Service Bulletin

Bulletin No: JC-17-04

Product Type: STEINER 440 (Kohler engines)

INTRODUCTION: This instruction sheet covers the installation of the Kohler Alternator harness kit 970965 into the Kohler 440 models.

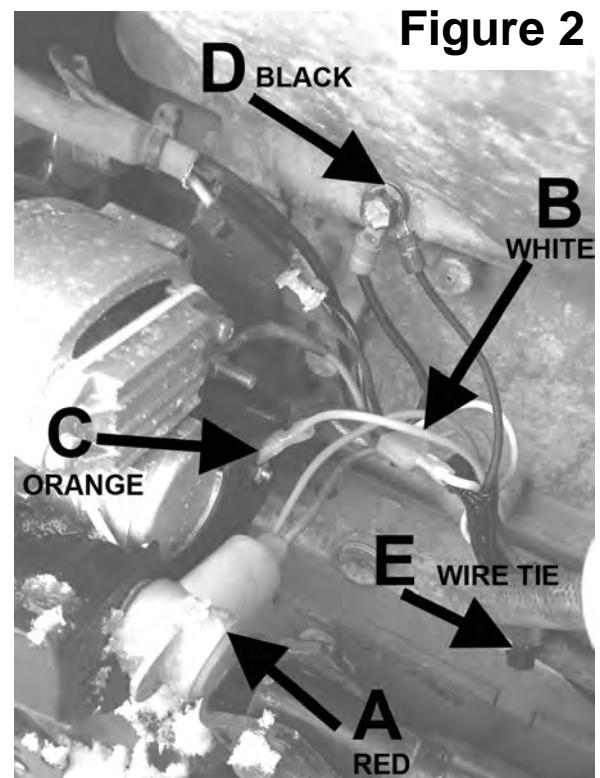
1. Disconnect the battery.
2. Remove existing oil cooler support bracket from the left side of the tractor and discard. Save fasteners for reuse later.
3. Install new bracket (**Item 3**) without any of the electrical components attached using the hardware removed in Step 2. Tighten hardware. (**Figure 1**)

4. Remove the relay (**Item 2**) from the relay holder. Install the relay holder in the inside bottom hole on the bracket with supplied screw (**Item 4**) and nut (**Item 5**). (**Figure 1**)

5. Reinstall the relay (**Item 2**) into the relay holder. (**Figure 1**)
6. Install the fuse holder into the upper hole using supplied screw (**Item 4**) and nut (**Item 5**). (**Figure 1**)

7. Route the harness (**Item 1**) under the engine fan shroud and along the frame rail with the fuel lines as shown. (**Figure 1**)
8. Route the red wire **A** from the harness through the existing red insulation cover and attach to the terminal post on the alternator. NOTE: Both the original and new red wires should be attached to the terminal post on the alternator. (**Figure 2**)

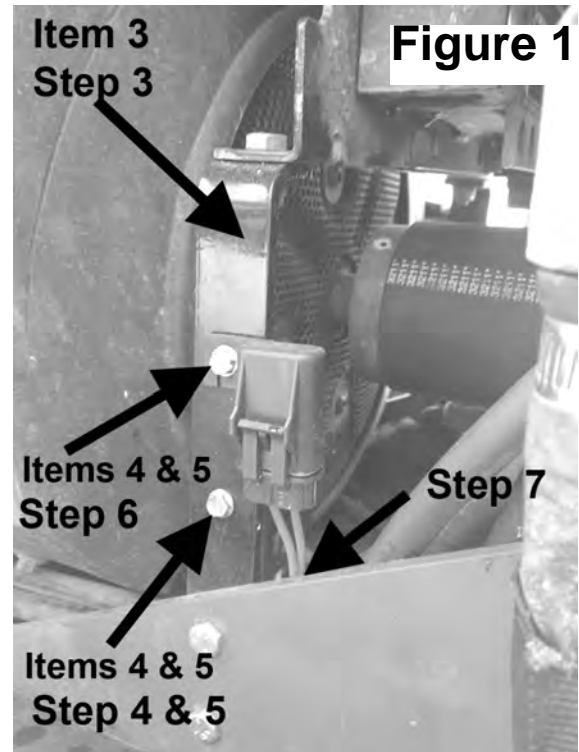
10. Remove the white wire **B** from the alternator and mate it to the white wire on the new wire harness. (**Figure 2**)
11. Connect the orange wire **C** from the wire harness onto the alternator where the white wire was removed in Step 10. (**Figure 2**)

12. Remove the ground fastener **D** from the engine, and attach the black wire from the new wire harness and reinstall fastener. NOTE: Both the original and new black wires should be reattached to the engine as shown.

13. Complete installation by securing the new harness to the existing fuel lines using the provided Zip tie **E** (**Item 6**).
14. Reconnect the battery.
